Though the authors have made substantial revisions to the manuscript, I believe that my prior comment regarding reservoir aggregation in major issue hasn't been addressed. I think the authors should improve their Methodology, and further update the results.

Figure A. Lumped systems in Canada and U.S.

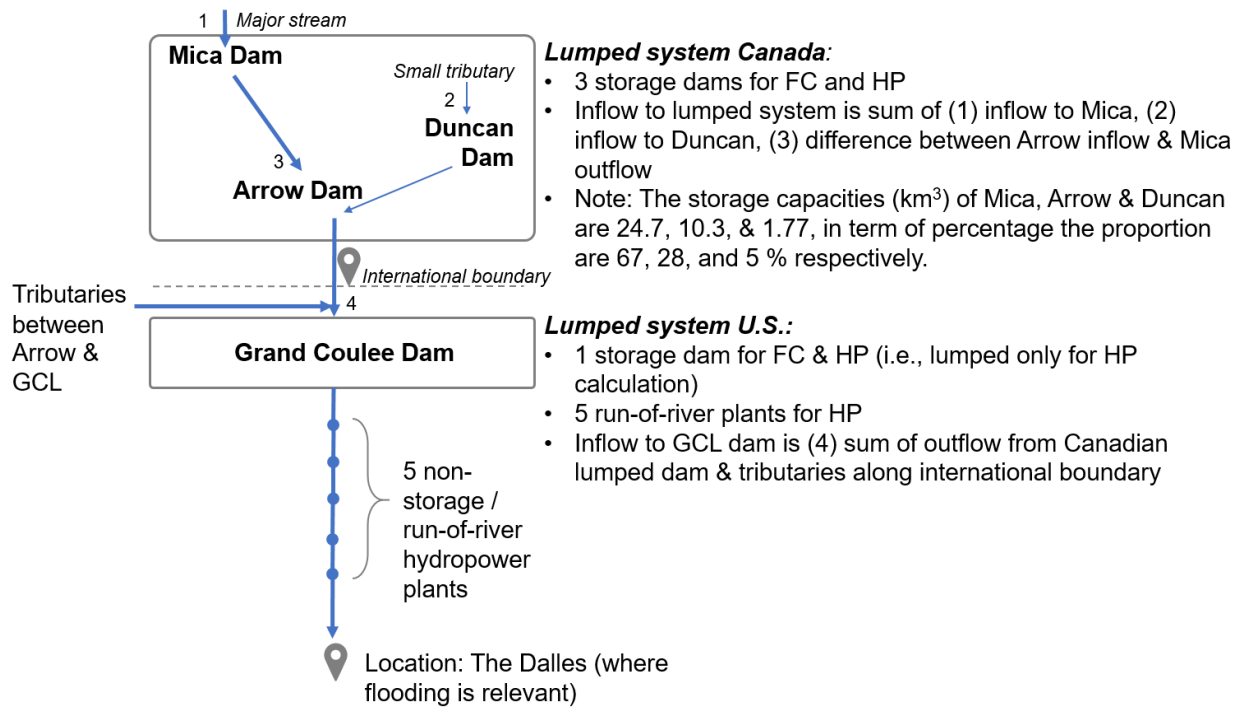
Lumping reservoirs storage for water supply may be reasonable when only focusing on the total amount of water supply. However, it's quite unjustified to lump reservoirs storage when it comes to flood control. Neither the hydrological connections between reservoirs nor the spatial distribution of flood is considered, which will lead the overestimated local flood control capacity, and further severe loss. A simple example is detailed below:

There are three cascade reservoirs A, B, and C, from upstream to downstream. The storages for flood control of A, B, C are 100, 200, and 300, respectively. Lumping reservoir storage indicates that the flood control storage becomes 600. The 600-level flood can be regulated through reservoir operation when the flood comes from upstream side of reservoir A. However, as the 600-level flood comes from the river segment between reservoirs B and C, the flood will exceed the regulate capacity of the system, which cannot be identified by lumping reservoir storage. Therefore, it's highly-risked to lump reservoirs storage for flood control.

We would like to illustrate our lumped system in the model through Fig. A below. In lumped system of Canada there are three treaty dams namely, Mica, Arrow and Duncan with their respective storages as 24.7, 10.3, and 1.77 km³, which are 67, 28, and 5% of the total installed storage respectively. The stream through Mica and Arrow Dams is the primary stream order of Columbia river and the one through Duncan is a small tributary. These three dams are combined to calculate flood control and hydropower. We did consider all the hydrological connections and segments that constitute the inflows for each lumped system, as shown in Fig. A. Similarly, in lumped system of the U.S. there is only one storage dam i.e., Grand Coulee (GCL) Dam and rest of the treaty dams are non-storage / run-of-river hydropower plants as shown below in Fig. A. Therefore, the storage is not lumped for the U.S., and reservoirs are only lumped for the hydropower estimation, which is appropriate given the run-of-river design. The schematic of the streamflow and dams is also presented in Fig. 1 of the revised manuscript; and the nature of treaty dams is also illustrated in Table. 1 of the revised manuscript.

Furthermore, in our model we also considered hydrological connection through the international boundary to the location at The Dalles where flood damage usually occurs. We considered the tributaries along the international boundary that contribute to inflow in lumped system in U.S. (or the GCL dam) along with the outflow from lumped Canadian system. As illustrated by the comparison of observed and simulated streamflow for GCL dam (Fig. 5c and Fig. 6c of the revised manuscript), our computation replicates streamflow patterns appropriately for the paper question and scope. In addition, the hydropower benefits (i.e., the response variable) that depends on the streamflow (the independent variable) included in the model was able to accurately reproduce hydropower benefits for the U.S. (Fig. 5d and Fig. 6d of the revised

The spatial distribution of the flooding is an important topic and is one of the major limitations of the lumped models. However, the spatial distribution of the flood is not relevant for the scope of this study because the historic flood damages occurred downstream of Columbia river at “The Dalles” and which was one of the key motivation for the CRT, thus in our study we considered flood control benefit by specifically considering flooding at The Dalles.
